Access Compliance Report

Public Rights-of-Way

Intersection ID: N/A	Main Street: KIRKWYND COMMONS DR	Cross Street: SHETLAND LN	Location: NE
ADA ID: 496FE84A6179	Ramp Type: Perp	Initial Pass/Fail: Fail	Overall Compliance: No
Codes/Mitigation Info/Possible Solution		Field Measurements/Component Compliance	
Severity Score: 25

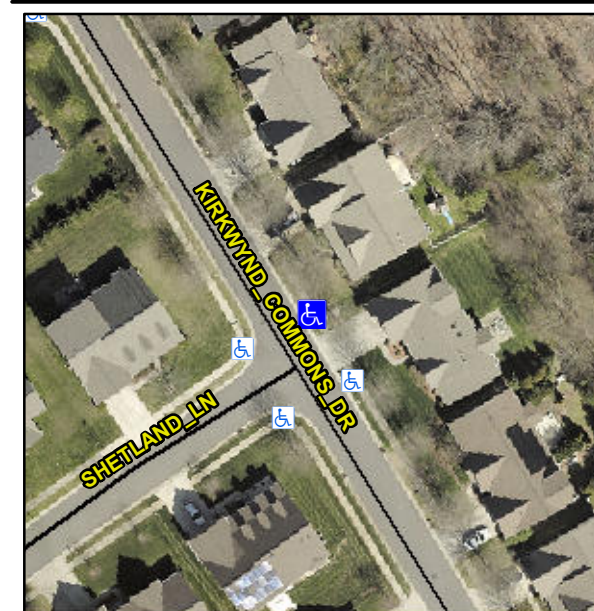
R304.2.2

Compliance	Description	Data	Compliance	Description	Data
N/A	Ramp Length (in)	46.0	No	Ramp Slope (%)	12.4
Yes	Ramp Width (in)	48.0	Yes	Ramp XSlope (%)	0.9
N/A	Flare Type LT	N/A	N/A	Flare Type RT	N/A
N/A	Flare Slope LT (%)	N/A	N/A	Flare Slope RT (%)	N/A
N/A	Flare Traversable LT?	N/A	N/A	Flare Traversable RT?	N/A
N/A	Landing Length (in)	N/A	N/A	DWS Provided?	N/A
N/A	Landing Width (in)	N/A	N/A	DWS Contrast?	N/A
N/A	Landing Slope (%)	N/A	N/A	DWS Length (in)	N/A
N/A	Landing X Slope (%)	N/A	N/A	DWS Full Width?	N/A
N/A	Landing Curb? (Y/N)	N/A	N/A	DWS Offset (in)	N/A
N/A	Shared Landing?	N/A			
N/A	Gutter Ponding?	N/A	N/A	Gutter Slope (%)	N/A
N/A	Gutter Lip Ht (in)	N/A	N/A	Gutter X Slope (%)	N/A
N/A	Painted X Walk1?	No	N/A	Painted X Walk2?	N/A
	X Walk 1 Direction	To SW		X Walk 2 Direction	N/A
N/A	X Walk 1 Width (in)	N/A	N/A	X Walk 2 Width (in)	N/A
	X Walk 1 Slope (%)	3.9		X Walk 2 Slope (%)	N/A
	X Walk 1 X Slope (%)	2.6		X Walk 2 X Slope (%)	N/A

Remove & Replace Entire Ramp.
